# Work Order ID 109795

Item Name: Mounting Plate

Work Order: <u>109795</u> Part No. <u>02957</u> NCR No. <u>14-3391</u>	<b>DISPOSITION</b> Rework <input type="checkbox"/> Scrap <input checked="" type="checkbox"/> Use-as-is <input type="checkbox"/> Work Order Update <input type="checkbox"/>	<b>AGAINST DEPARTMENT/PROCESS</b>

<b>DART AEROSPACE LTD</b>		<b>Work Order:</b>	109795
<b>Description:</b> Mounting Plate		<b>Part Number:</b>	D2957
<b>Inspection Dwg:</b> D2957 <b>Rev:</b> B		Page 1 of 1

DESIGN RF	DRAWN BY RF	DART AEROSPACE LTD HAWKESBURY, ONTARIO, CANADA	
CHECKED [Signature]	APPROVED [Signature]	DRAWING NO. D2957	REV. B SHEET 1 OF 1
DATE 00.07.06		TITLE MOUNTING PLATE	SCALE 1:1
A	00.01.20	NEW ISSUE	
B	00.07.06	MODIFY CORNER DETAIL

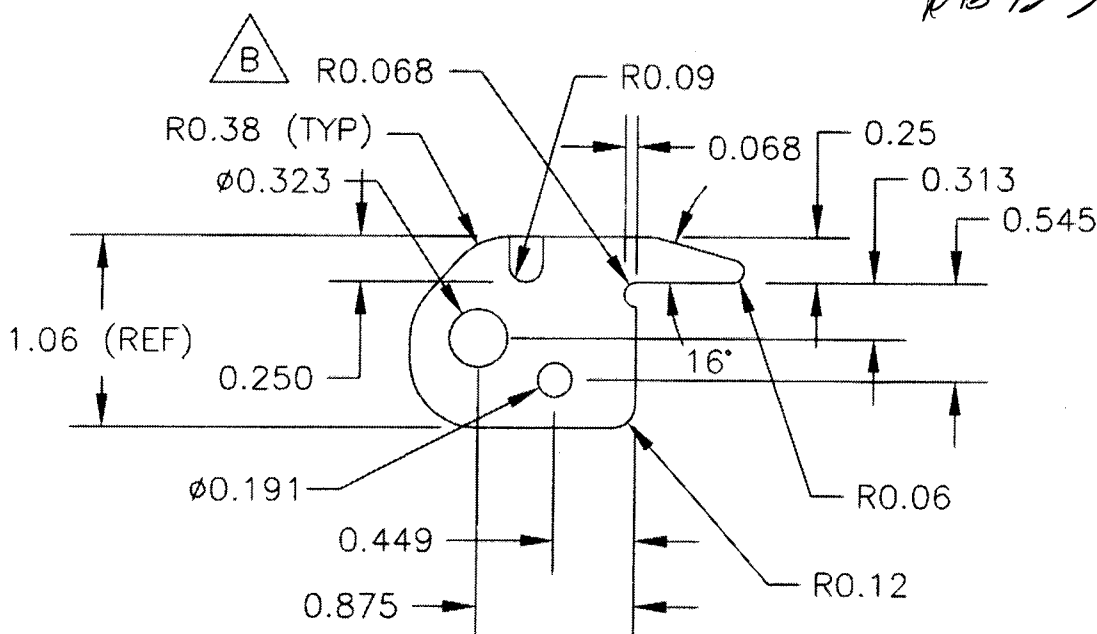
Root Cause	Date	Step	Qty	Description of work order update or Non-conformance	Initial Chief Eng	Action Description	Sign & Date	Verification	QC Inspector
Doc/Data <input type="checkbox"/>	13/12/20	110	1	<i>measure .250 (Ref) is under tolerance .183</i>  <i>piece lifted up in the vise when machining</i>	DAS 27 9-89  13/12/20	<i>Scrap no replace</i>  \$23.20	13/12/20	DAS 27 9-89  13/12/20	DAS 27 9-89  13/12/20
Equip/Tooling <input type="checkbox"/>									
Operator <input type="checkbox"/>									
Material <input type="checkbox"/>									
Setup <input checked="" type="checkbox"/>									
Other <input type="checkbox"/>									
Process <input type="checkbox"/>									
Supplier <input type="checkbox"/>									
Training <input type="checkbox"/>									
Unapproved <input type="checkbox"/>

0.250 (REF)  $\pm 0.015$   
PER ANS 35.2
